To: Town of Reading Community Planning and Development Commission
From: Dennis Carr, 61 Temple Street, Reading MA
RE: 186-190 Summer Ave.— Criterion Child Enrichment Project
Date: December 8, 2014

Site Plan Requests from 186 Summer Ave Abutters

To: George Zambouras, P.E., Town Engineer, Reading Massachusetts
From: Dennis Carr, 61 Temple Street, Reading MA
RE: 186-190 Summer Ave.– Criterion Child Enrichment Project
Date: January 5, 2015
cc: Jessie Wilson, Community Development Administrator, Reading Massachusetts

Remaining Site Plan Requests from 186 Summer Ave Abutters

FIGURE 1 TYPICAL POROUS PAVEMENT INSTALLATION

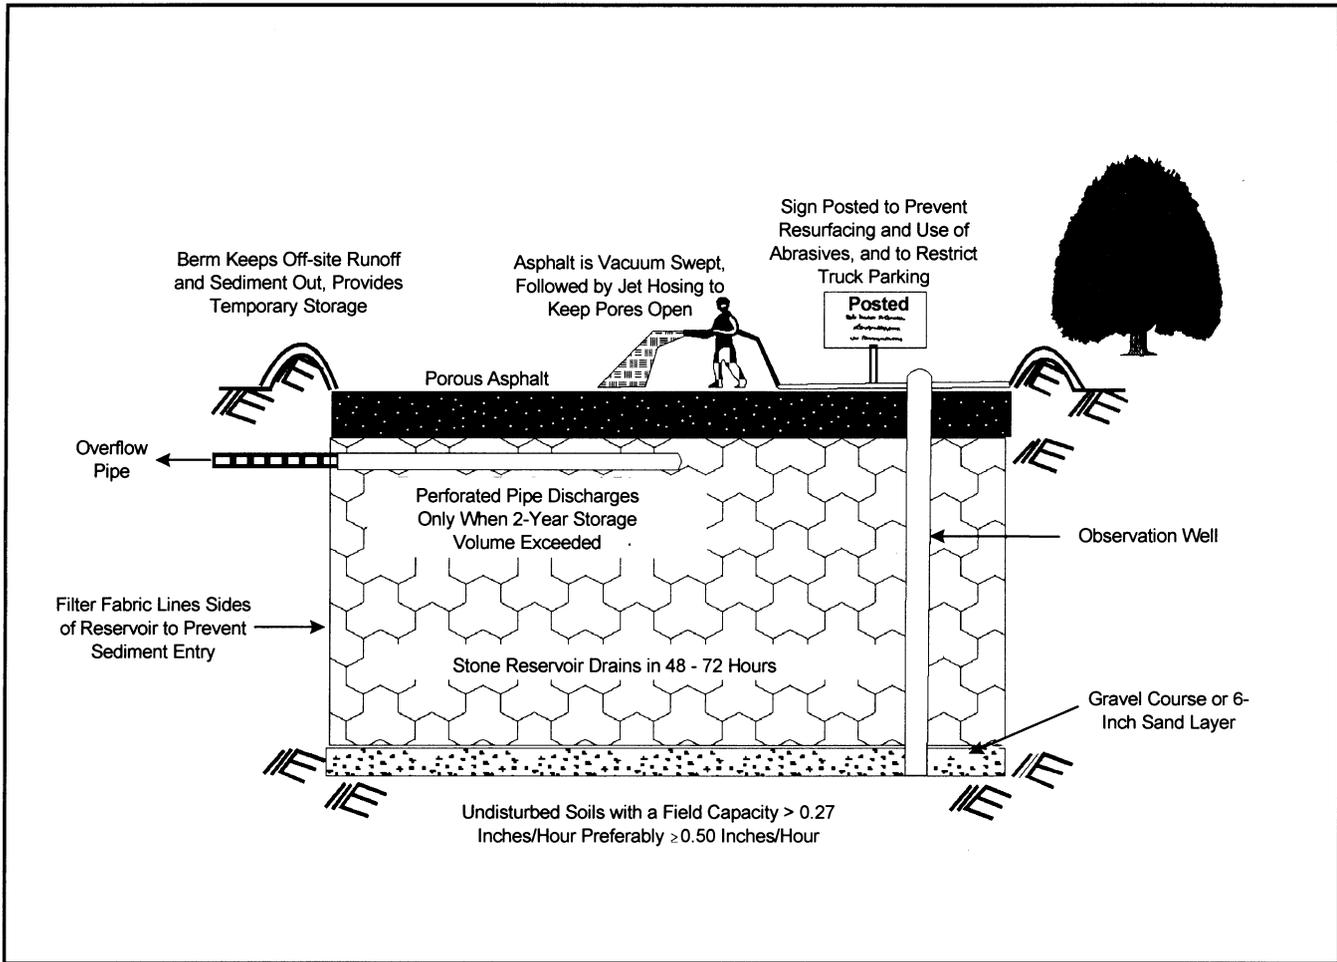
The porous pavement surface is typically placed over a highly permeable layer of open-graded gravel and crushed stone. The void spaces in the aggregate layers act as a storage reservoir for runoff. A filter fabric is placed beneath the gravel and stone layers to screen out fine soil particles. Figure 1 illustrates a common porous asphalt pavement installation.
